ADDENDUM NO. 1

MIDWESTERN STATE UNIVERSITY
MOFFETT LIBRARY RENOVATION
PHASE I

Addendum Date: 2 April 2018

A-201

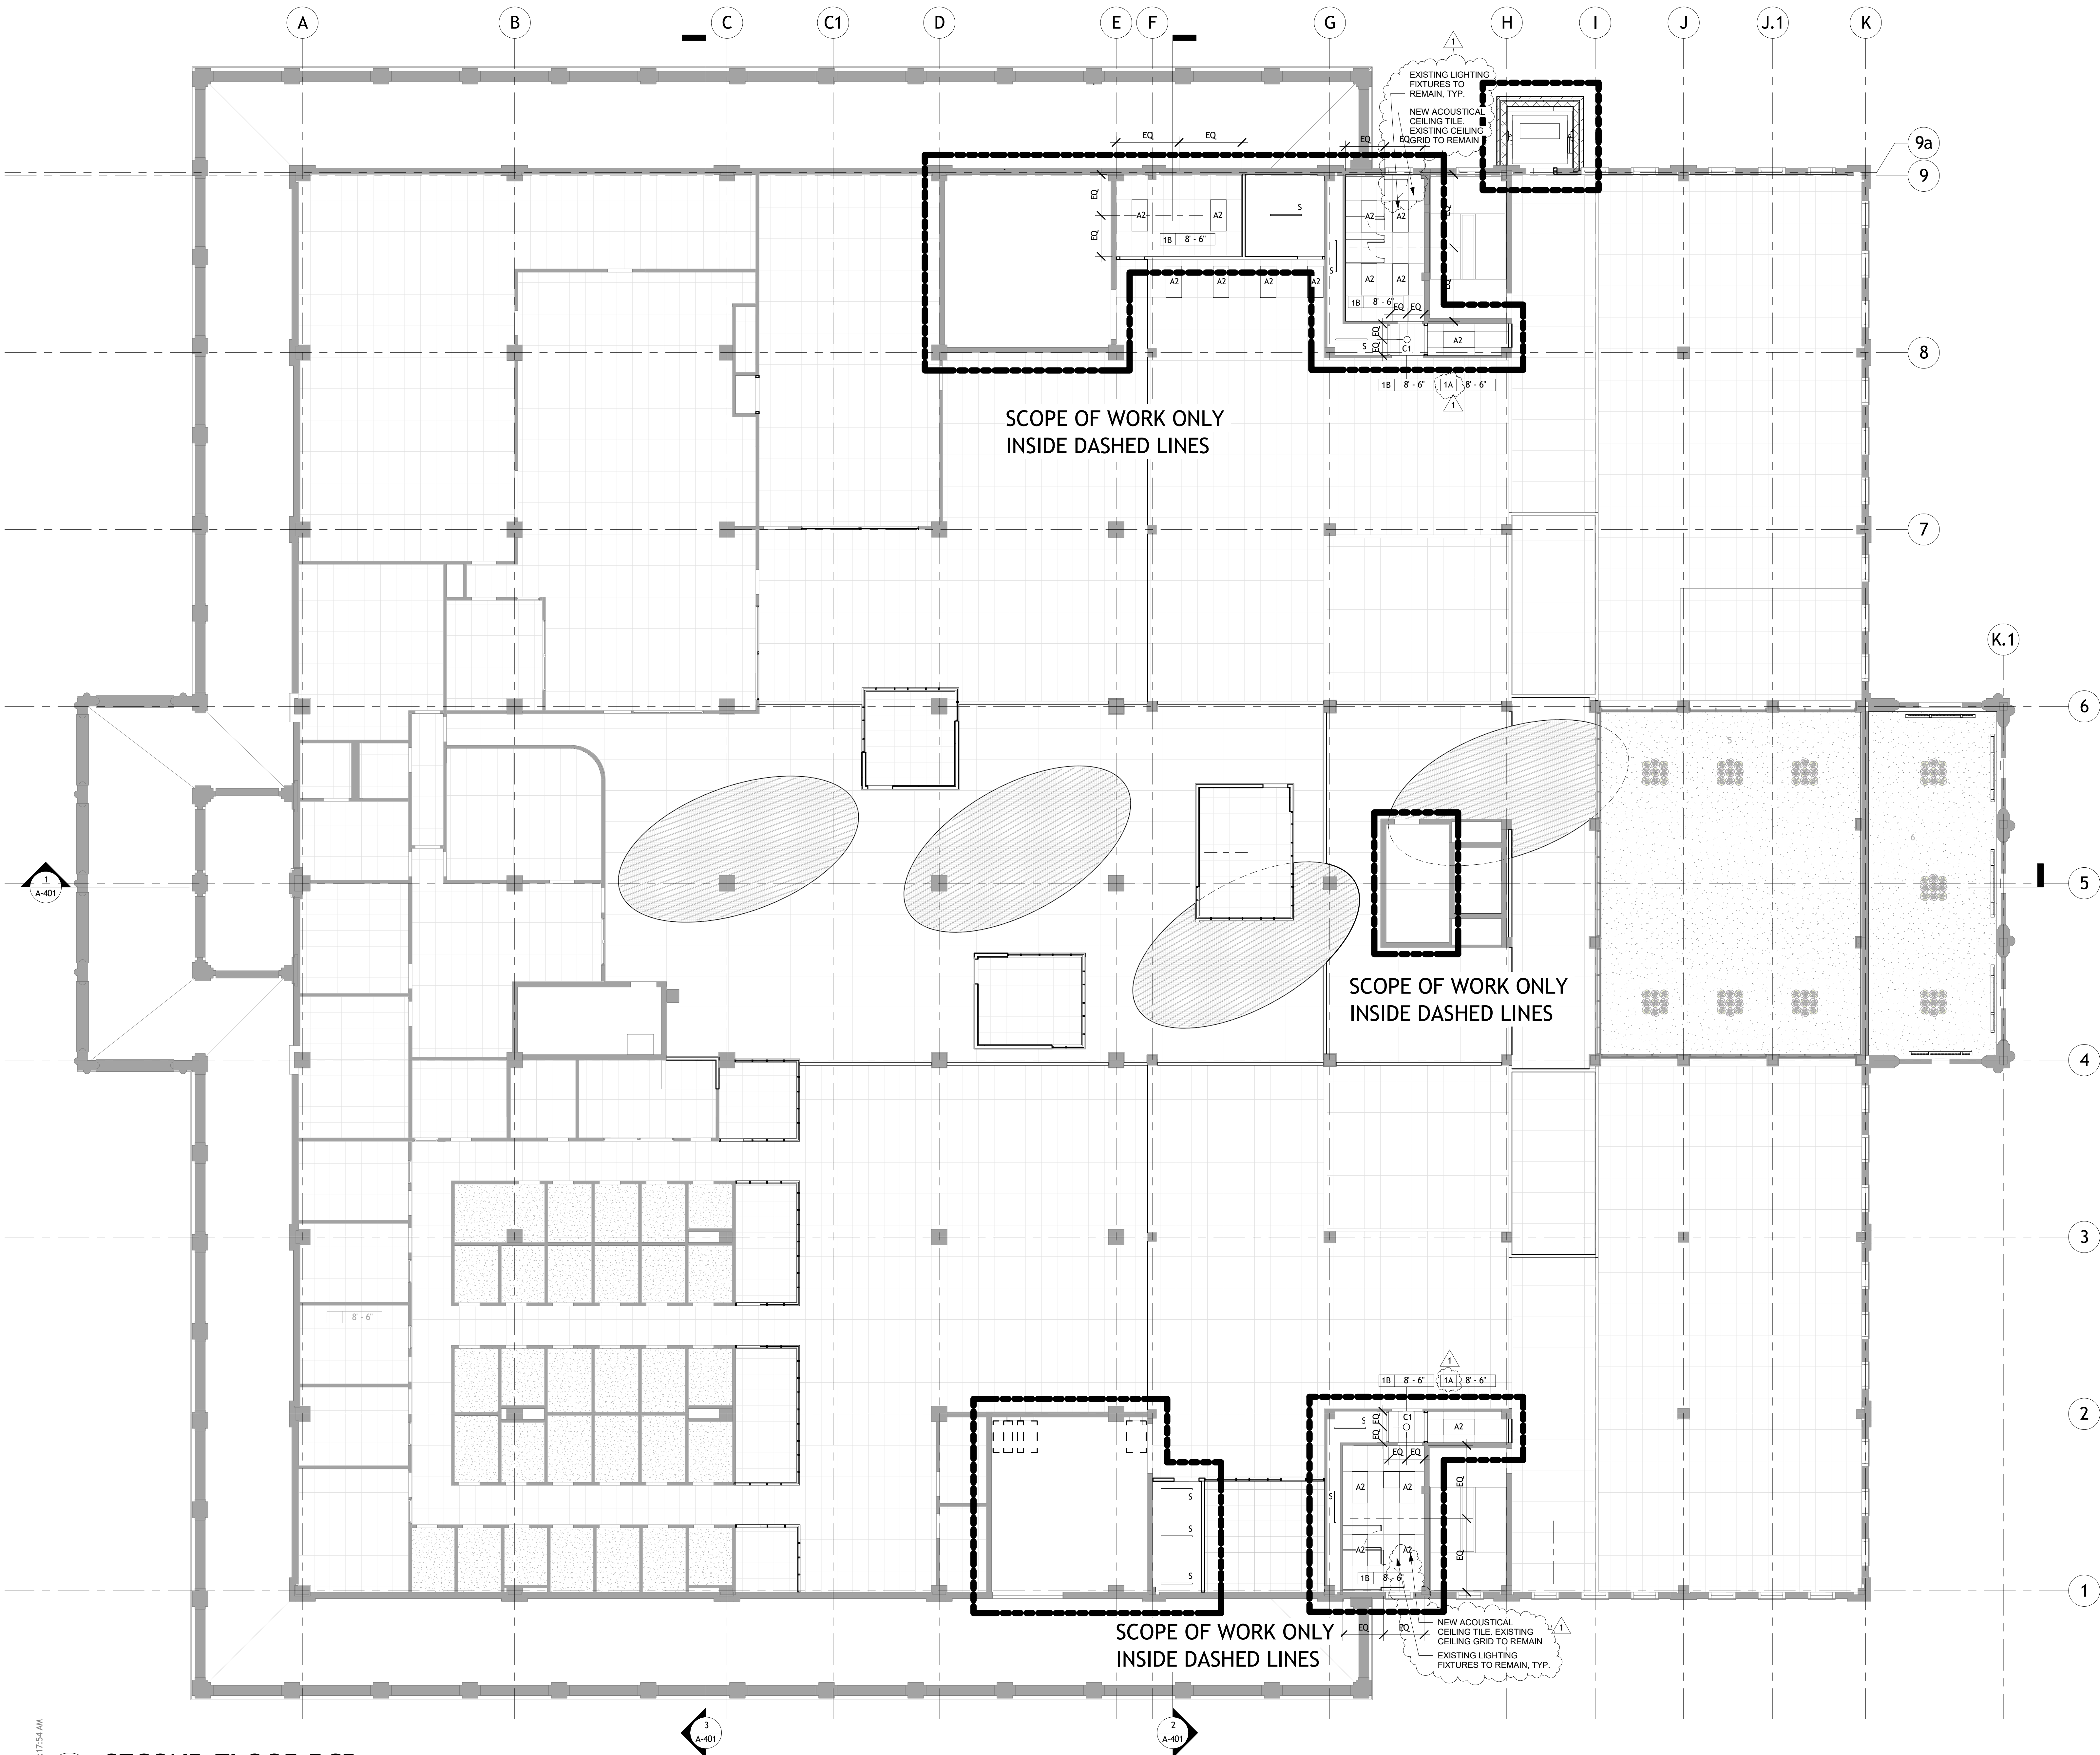
Replace the Drawings with the revised Sheets attached in this Addendum. The "Reflected Ceiling Plans" and "ROOM FINISH SCHEDULE" have been revised to clarify any conflicts in ceiling finishes and to show the added IT Closet areas ("IT CLOSET 1COMM2" and "IT CLOSET 2COMM2"). As clarification to the "FINISH SCHEDULE" on Sheet "I-001", in "IT CLOSET 1COMM1", "IT CLOSET 1COMM2", "IT CLOSET 2COMM1", "IT CLOSET 2COMM2", and "IT CLOSET 3COMM1",

DETAIL 07/S-401

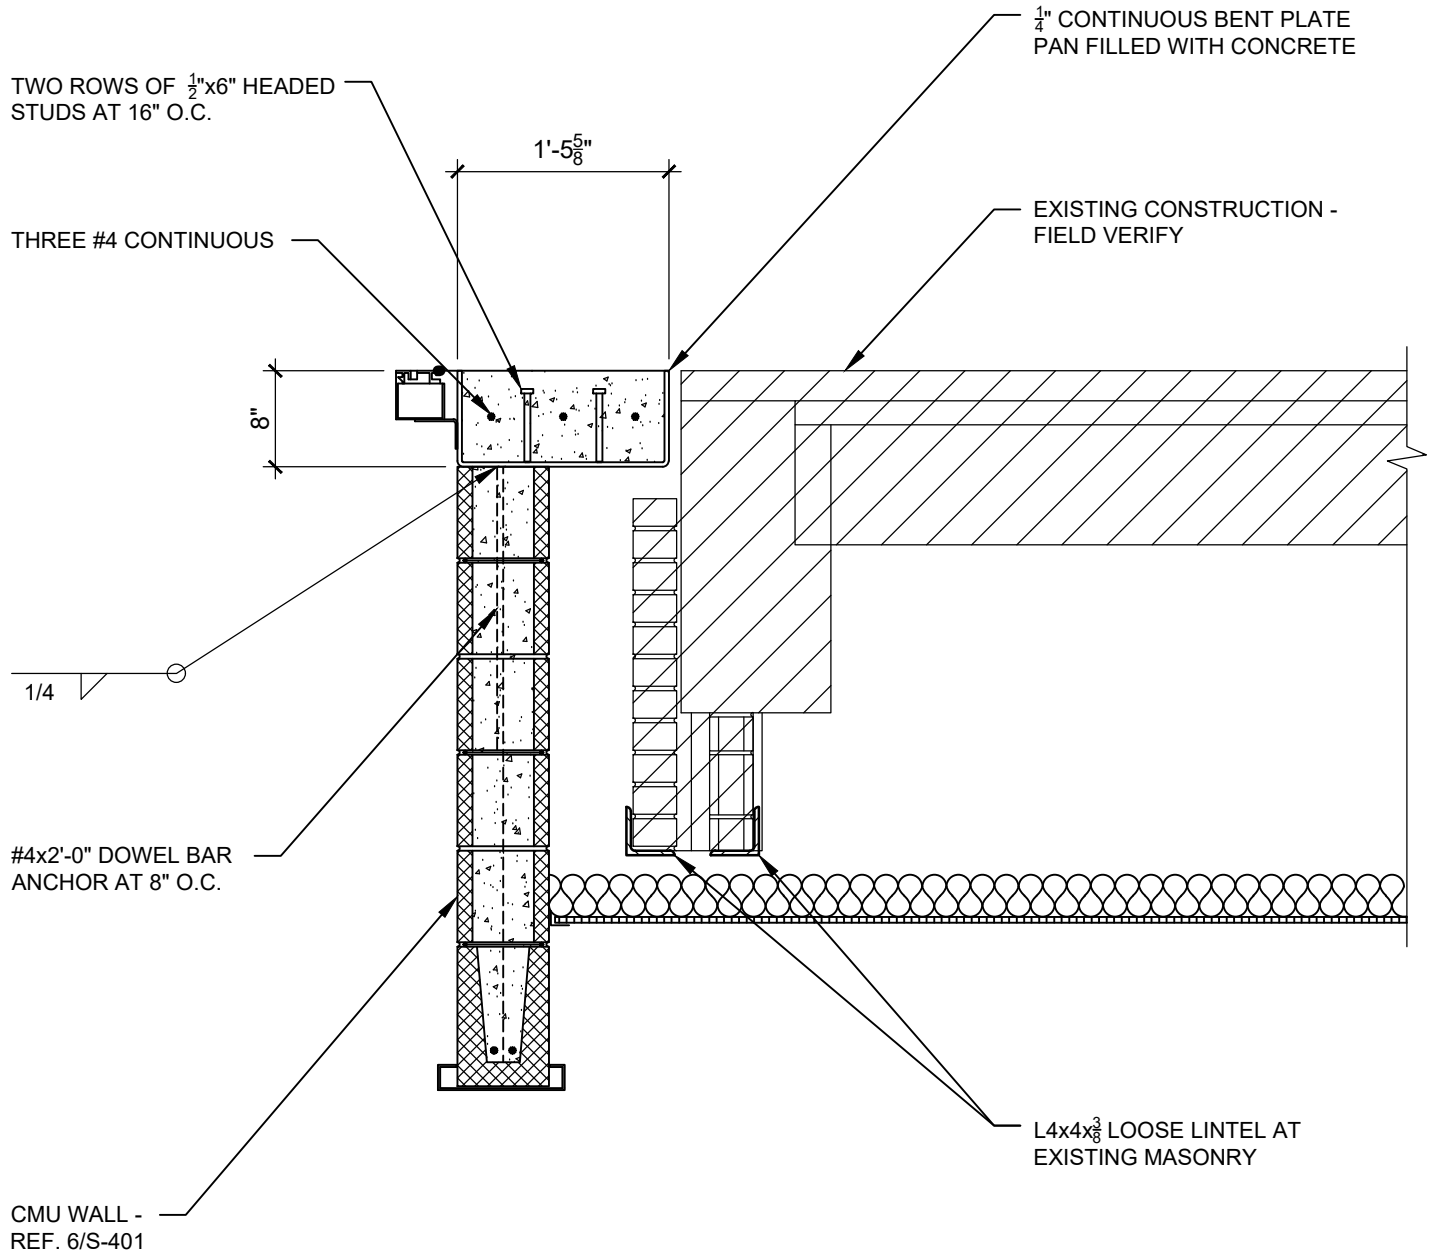
Replace the Detail with the revised Detail attached in this Addendum. The revised Detail clarifies the dimensions of the continuous steel bent plate.

**NOTE: THE BENT PL. IS ONLY
REQUIRED AT THE WIDTH OF THE
ELEVATOR DOOR AT EACH FLR.**

M-101

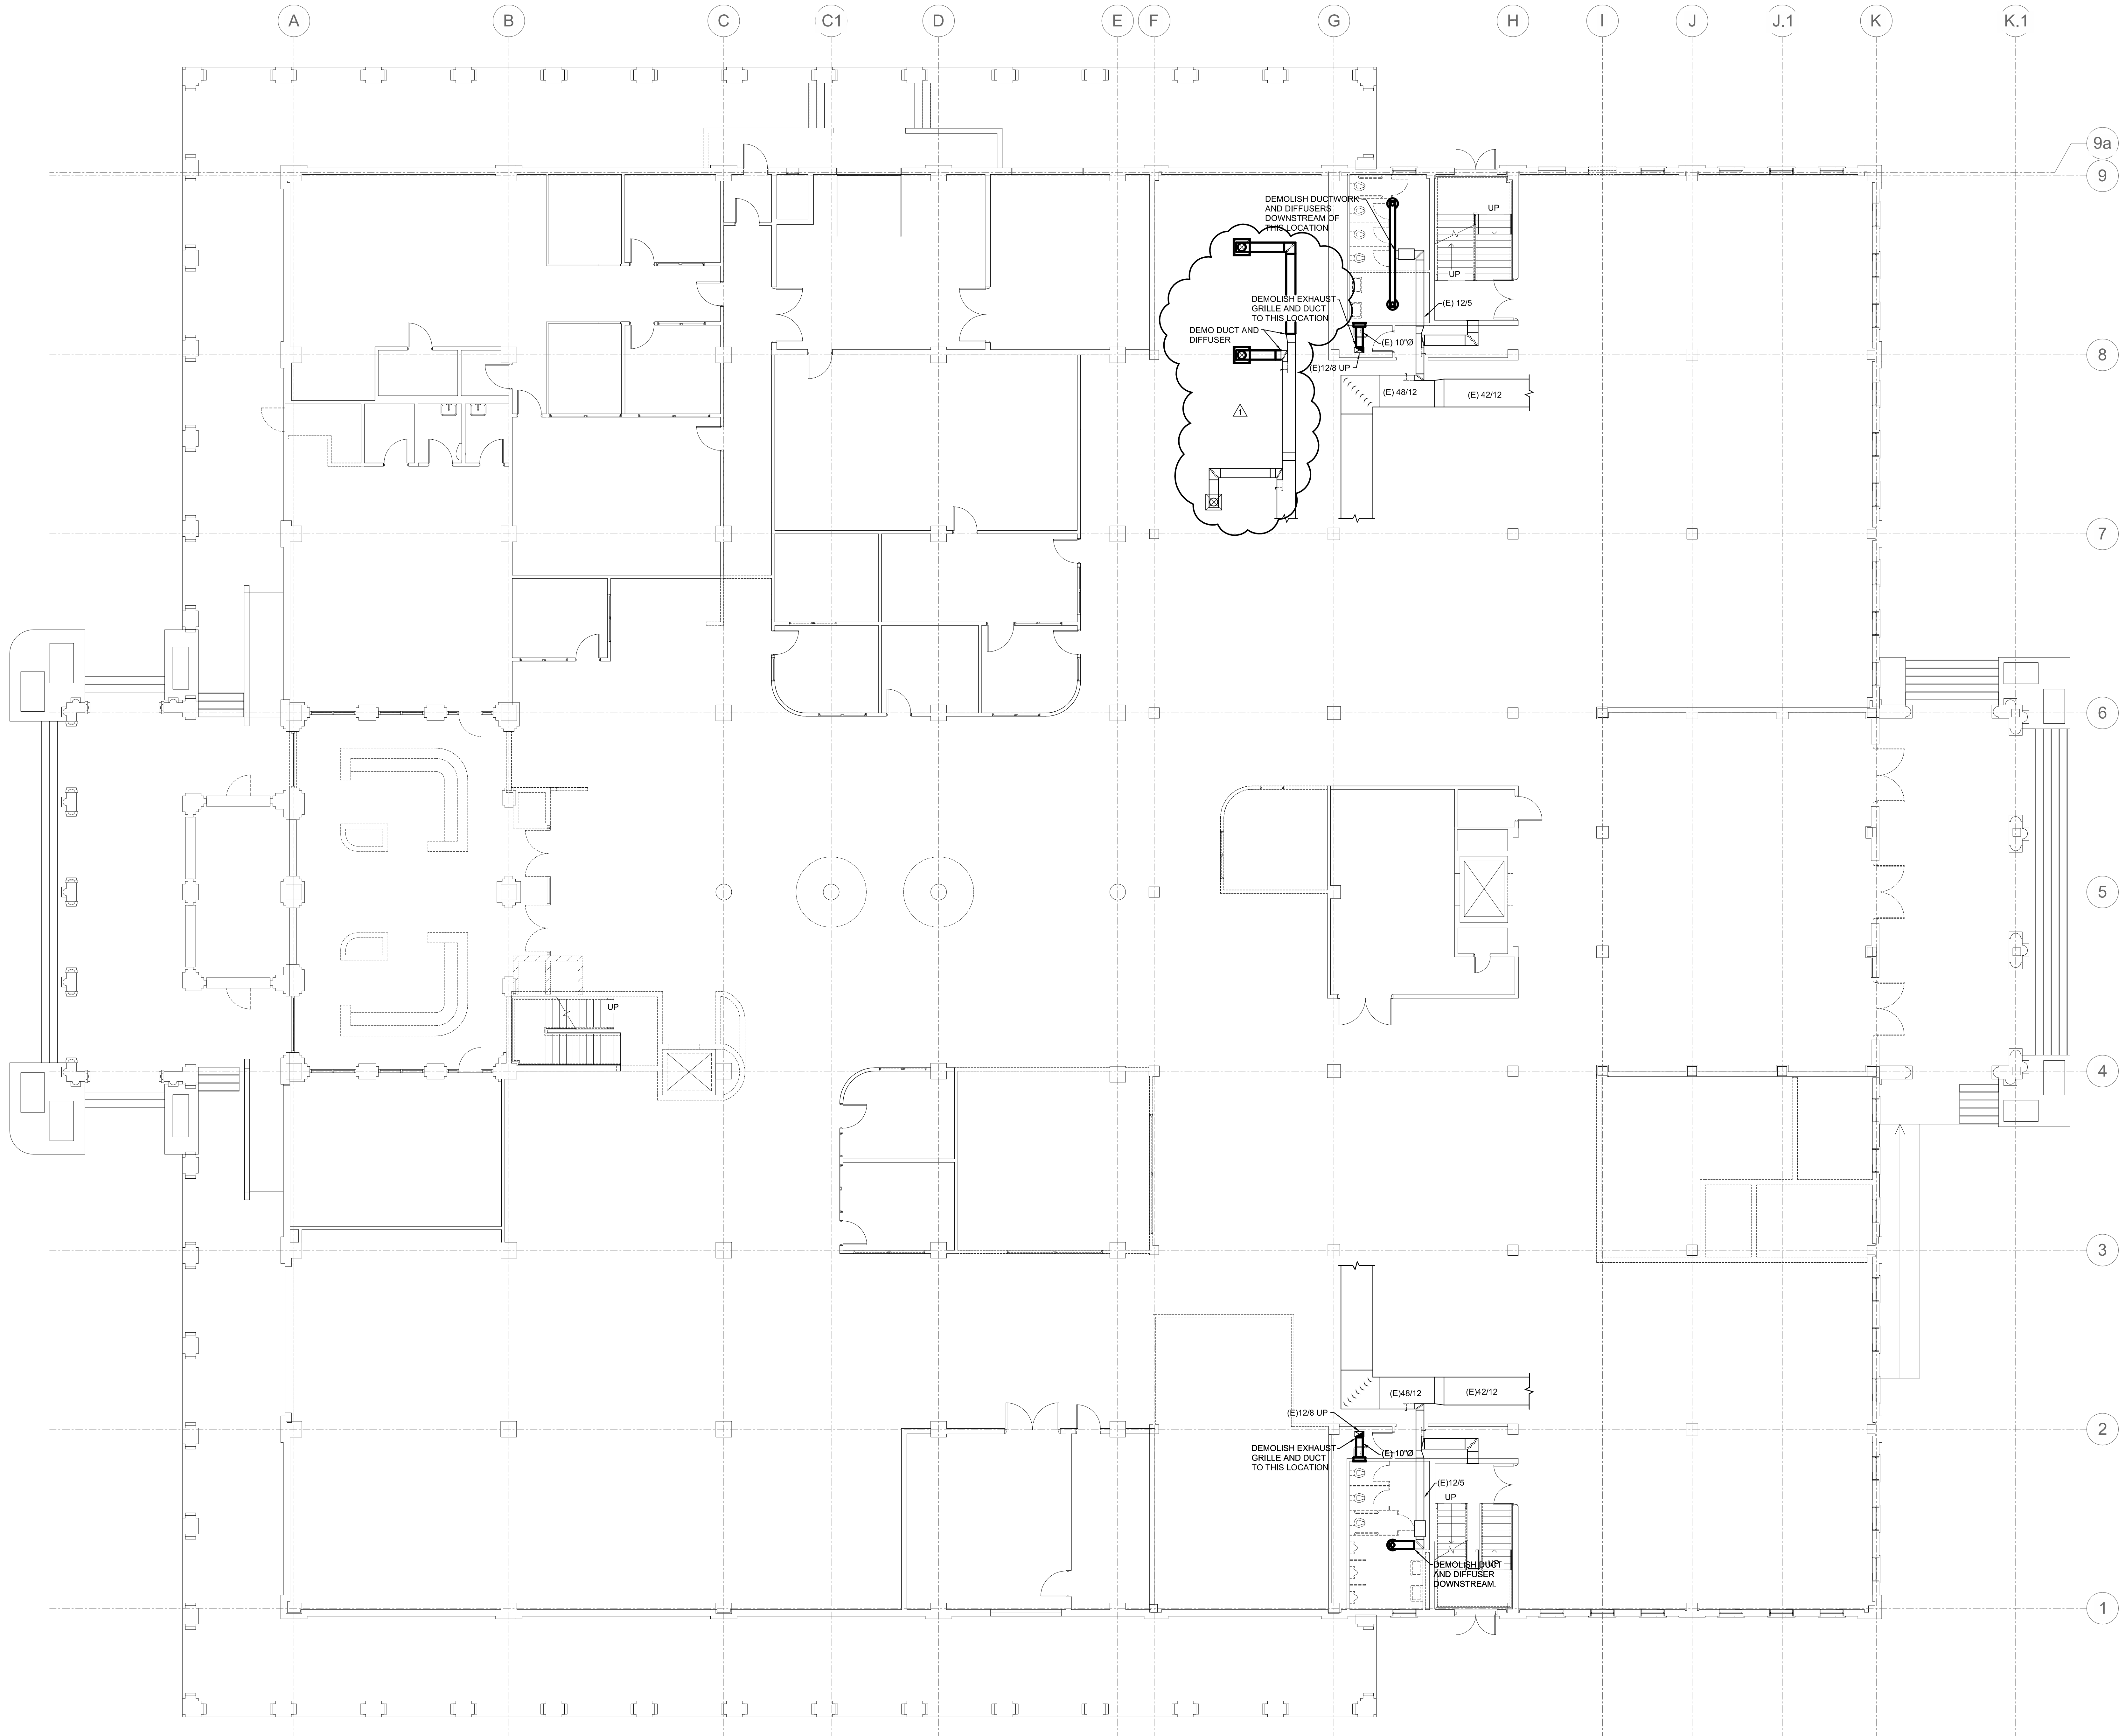
Replace the Drawings the revised Sheets attached in this Addendum. Additions and revisions have been made to the Mechanical Plans on all Floors, mainly relating to IT Closets.
